PROJECT: The Finches Development

RFI Response Document

Below are our comments/response to items raised in request for Further Information regarding Planning Ref: SD21A/0216

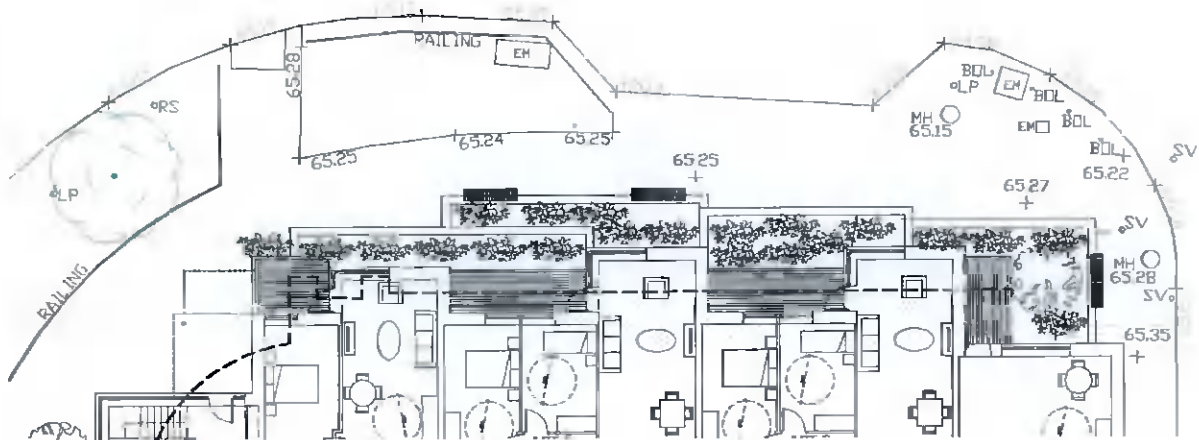
(a) The entrance to the apartments is adjacent to the proposed public house entrance, which is not considered appropriate. The apartment entrance is also overly narrow, concealed and is not of a significant design. The Planning Authority recognises that the location of the site at the important roundabout nodal point would require a more substantial design feature, which a redesigned entrance could deliver. In this regards the applicant is requested to submit a full redesign of the north-western corner of the development to provide for a more substantial and welcoming entrance to the apartments. This revised feature should be provided with ample natural light, which should also contribute to the lighting of the internal corridors.

We have updated the north-western corner in response to this request. We have reduced apartment 1 from a 2 bed apartment to a 1 bed apartment. This has allowed us to enlarge the entrance lobby and relocate the entrance doorway away from the Public House on Neilstown Road and over onto Collinstown Road. The stairwell has now been fully glazed which will form a striking architectural feature, addressing the corner of the site to the roundabout. The extent of glazing to the stairwell and the relocation of the lift shaft will enhance the entrance lobby and will provide natural light into the ground floor common areas and upper floor corridors.

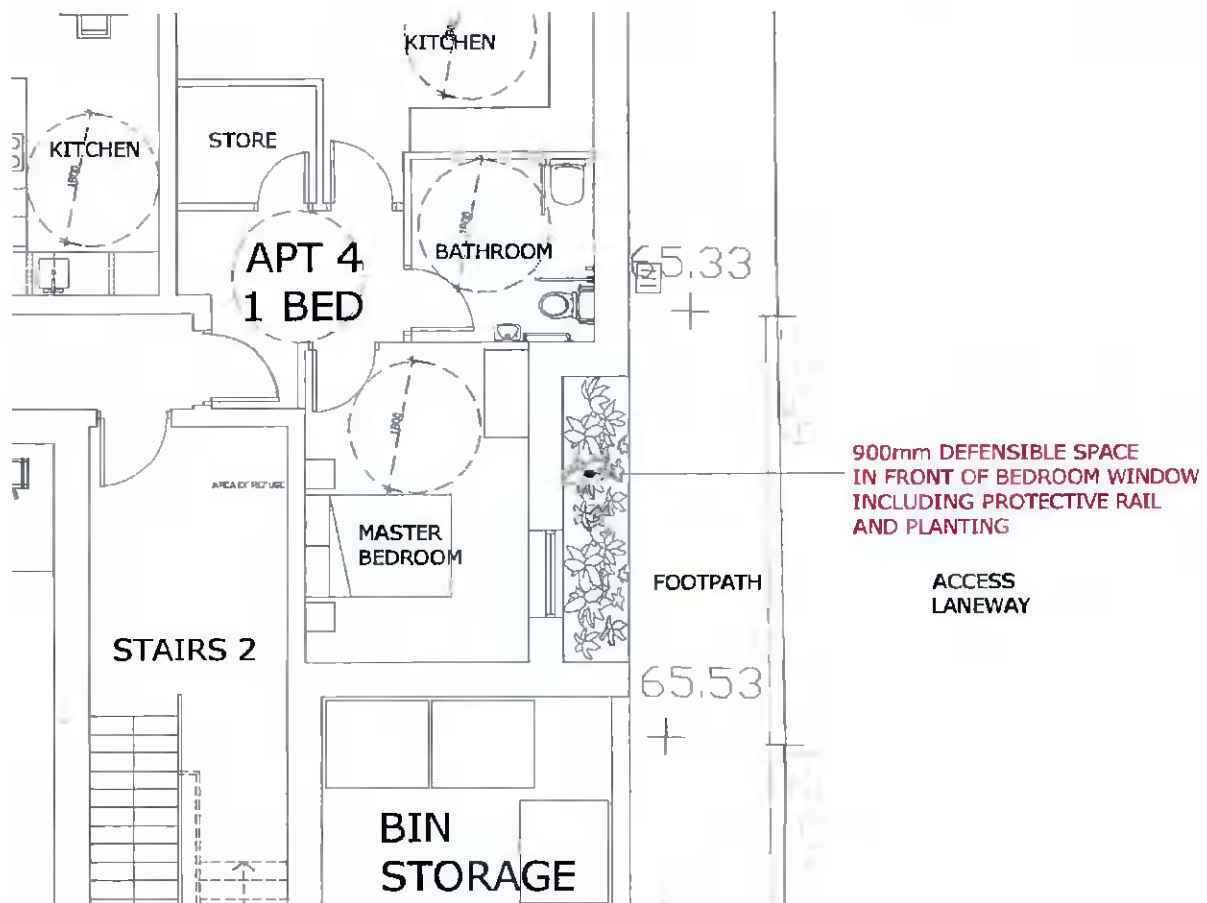
(f) It is not clear whether the proposed bin store is for the apartments or the public house or both. The applicant is requested to clarify this and submit detail confirming sufficient bin store can be provided for both uses.

Separate bin store for public house is to be in the open yard to the south with access to the ground level carpark. The open yard is also to be roofed over. See revised drawings.

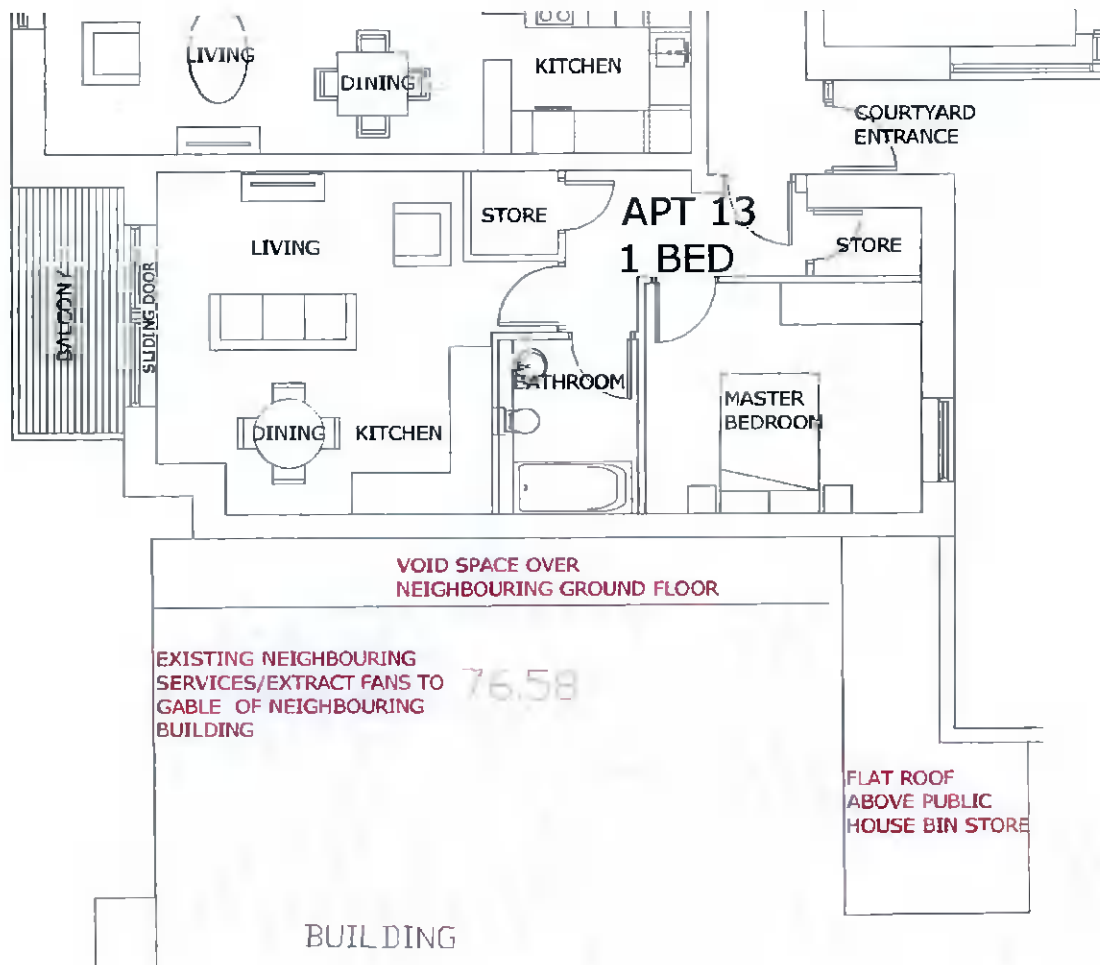
(g) The Planning Authority is concerned that the construction of the eastern building facade of the three-storey element up to the boundary with the access laneway, which is provided with a narrow footpath, rising and dropping (on the western side of the laneway) and with no pathway (on the eastern side of the laneway) would represent substandard design/development, especially considering the location of a ground floor bedroom at this location (Apartment No. 4).

The applicant is requested to submit a full redesign of the development at this location to 1) increase the size of the footpath and 2) to provide a minimum of 0.9m privacy strip/defensible space between the footpath and the eastern façade. 3) provide windows open to increase natural light to the internal corridors.

The existing ramp and railing on the western footpath which currently acts as a ramp for the existing emergency exit to the existing public house and reduces to 1700mm is no longer needed and will be removed. The existing public footpath is 2m wide and now will be level with the proposed development. 2m's wide is more than enough space further to the requirements of TGD M 2010 and would be adequate as a public footpath, especially in a low vehicular and pedestrian trafficked area.

In response to giving a defensive space to the bedroom of Apartment No. 4 we have updated our drawing to show a 900mm setback for the bedroom. This will be further secured with a protective railing and some planting at the edge of footpath.
